PRODUCT CHANGE NOTIFICATION (PCN)

PCN Number: 07/2023

Title: boost V Design Improvement

Product Family: boost V

New boa5120-150 technical drawing

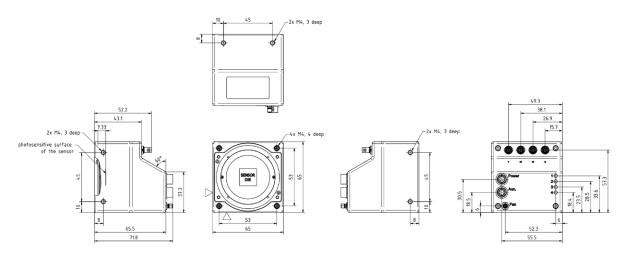
The following housing dimensions, including accessories and mounts have changed:

Camera model	Old dimensions (L x W x H)	New dimensions (L x W x H)
boA5120-150cm/cc	71 mm x 65 mm x 65 mm	65.5 mm x 65 mm x 65 mm
boA5120-230cm/cc	76 mm x 65 mm x 65 mm	66.6 mm x 65 mm x 65 mm
boA9344-70cm/cc	71 mm x 65 mm x 65 mm	66.6 mm x 65 mm x 65 mm

With the mount adapter installed, the cameras are the same length as before the change. The optical distance remains the same, so that customers can keep their existing optical setup.

Due to the changed dimensions, the bore depth of the mounting threads in the front have been reduced slightly.
